FINAL PLAT OF
"HINDU TEMPLE ADDITION"

WICHITA, SEDGWICK COUNTY, KANSAS
IN THE NW 1/4 OF SECTION 22, T27S, R2E OF THE 6TH P.M.

SUB 2001-39 -- One-Step Final Plat of Reddi Addition

STAFF REPORT
(One-Step Final Plat Approved 4/26/01)

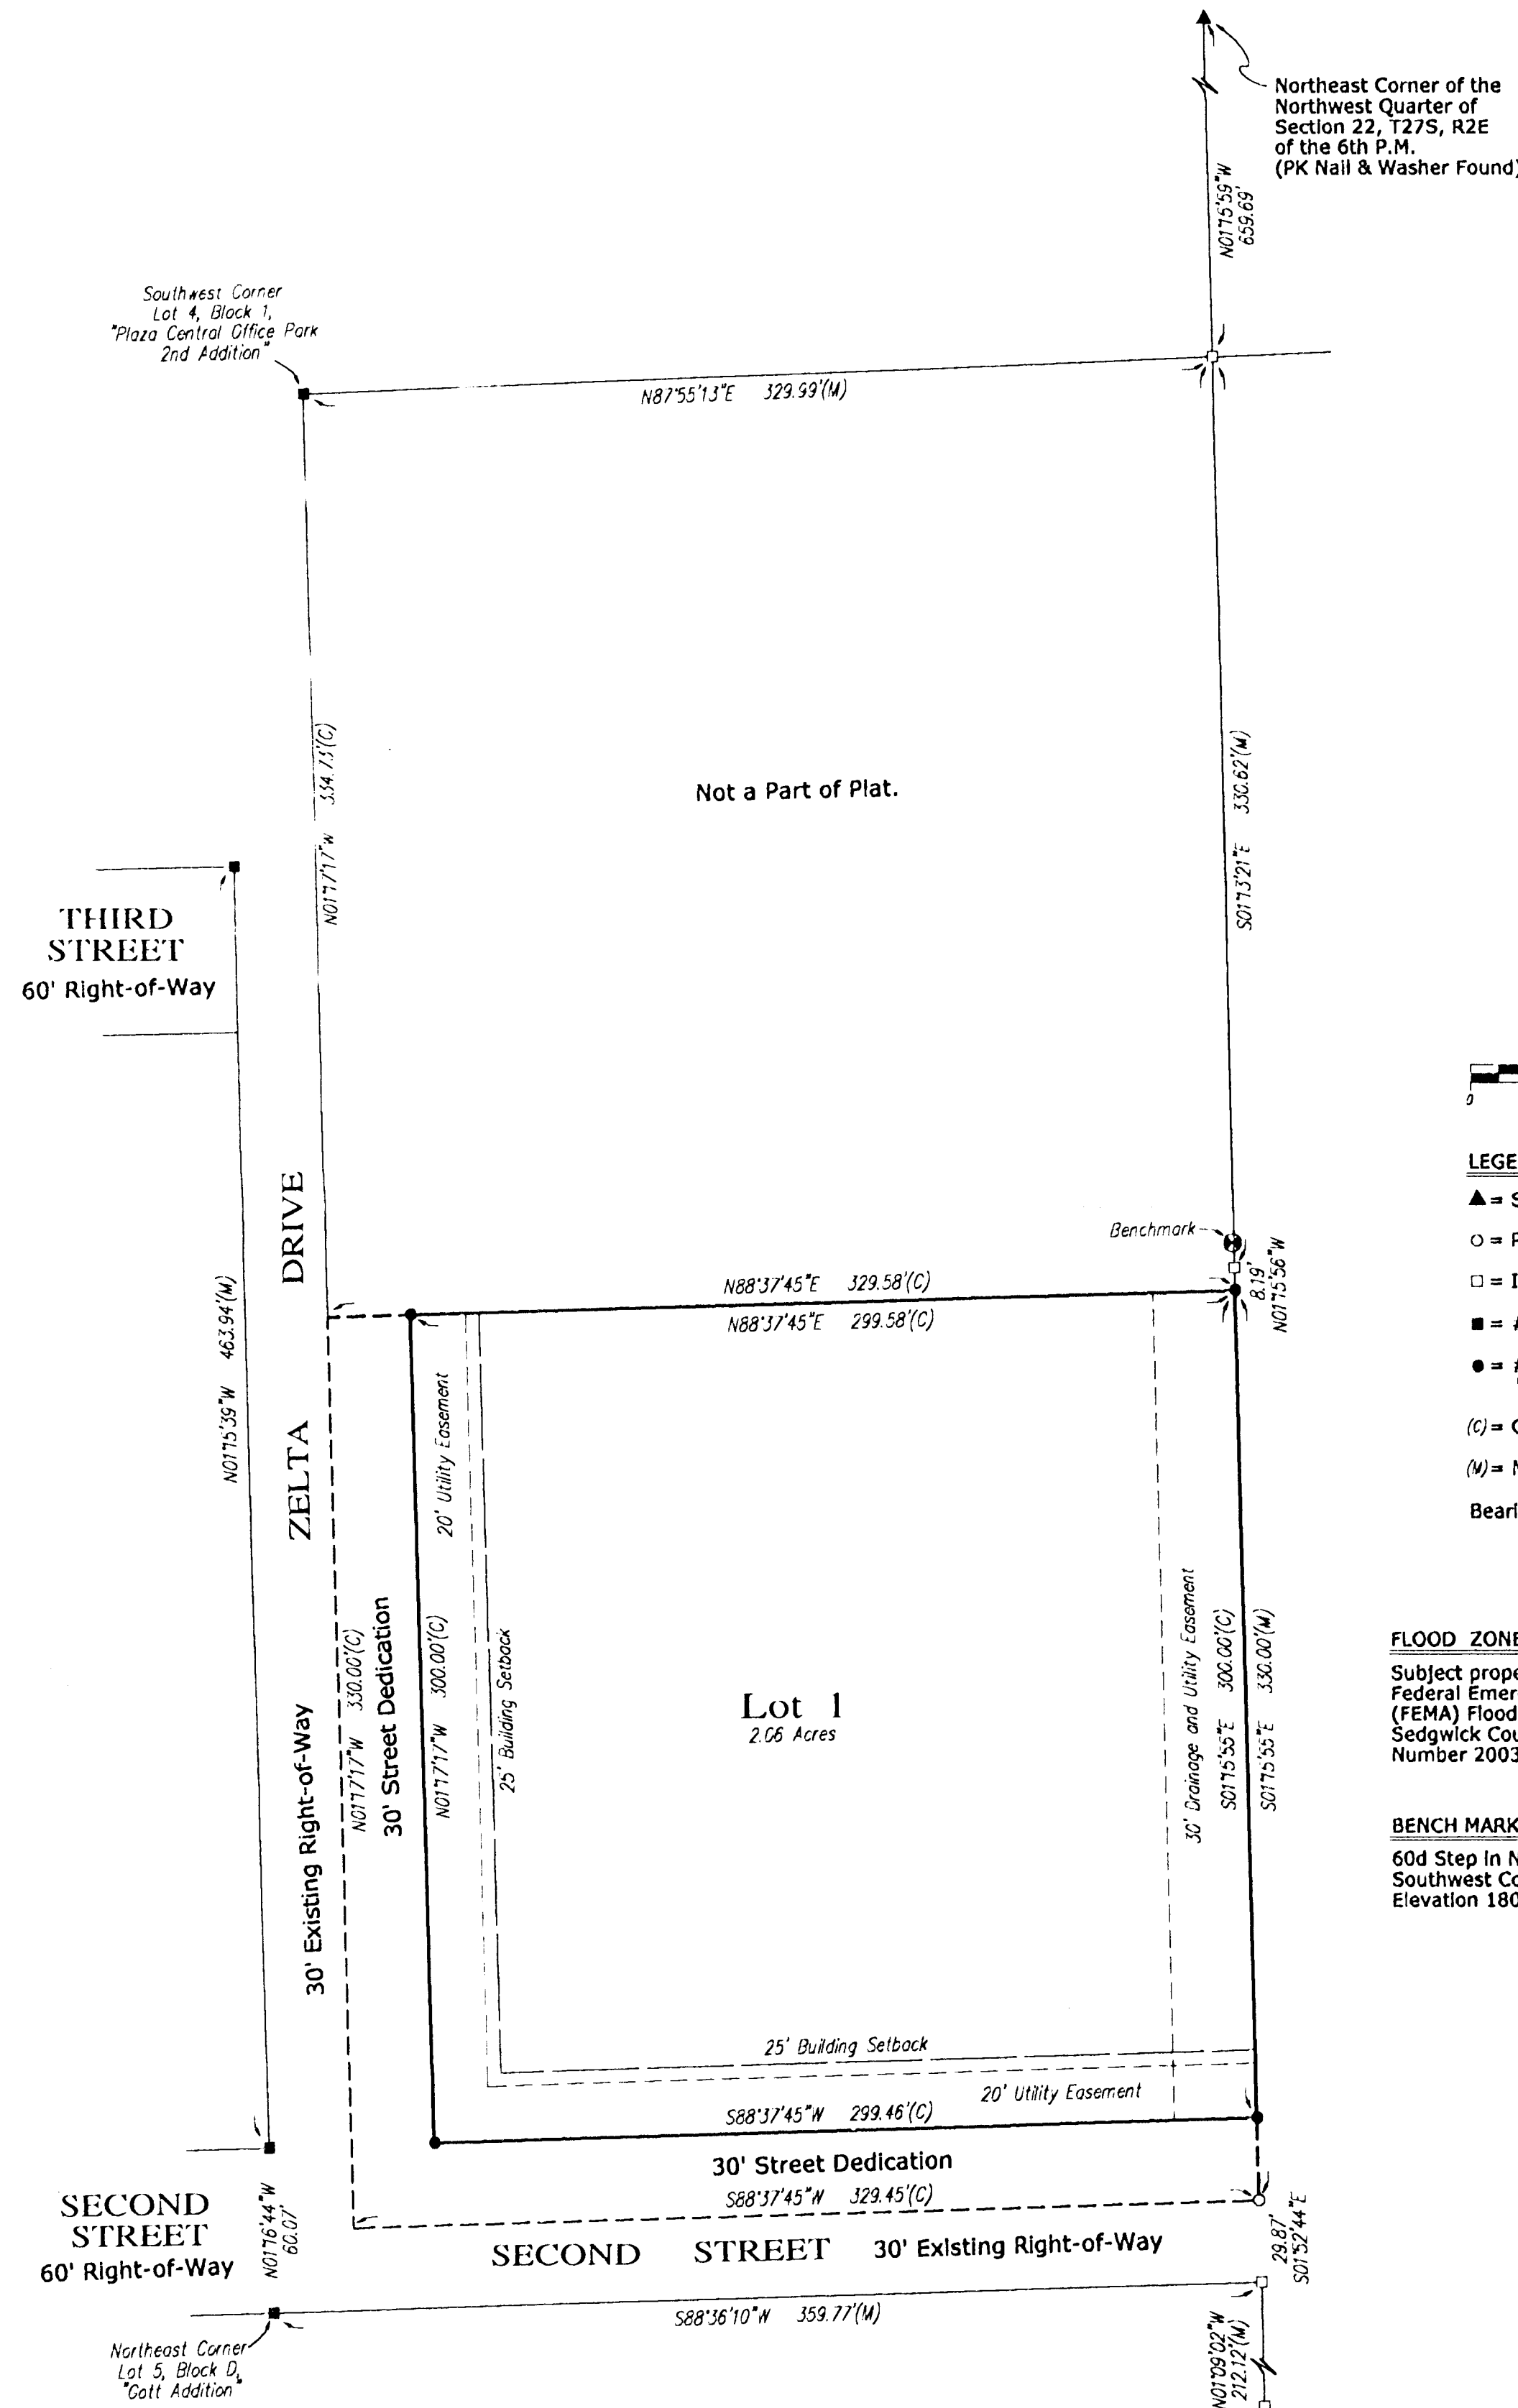
- D. City Engineering needs to comment on the status of the applicant's drainage plan. The drainage plan is needed. An off-site drainage agreement is required.

- E. The applicant shall guarantee the installation of Second Street to a roadway width of 31-ft back of curb to back of curb.
- F. The applicant shall provide a No Protest Agreement for future improvements to Zelta.

- G. The paving guarantee shall include the installation of an "L" or "T" type turnaround at the terminus of Second Street at the plat's east line.
- H. On the final plat, the MAPC signature block needs to reference "J.D. Michaelis, Acting Chair".

- J. The platlor's text shall include language that a drainage plan has been developed for the plat and that all drainage easements, rights-of-way, or reserves shall remain at established grades or as modified with the approval of the applicable City or County Engineer, and unobstructed to allow for the conveyance of stormwater.
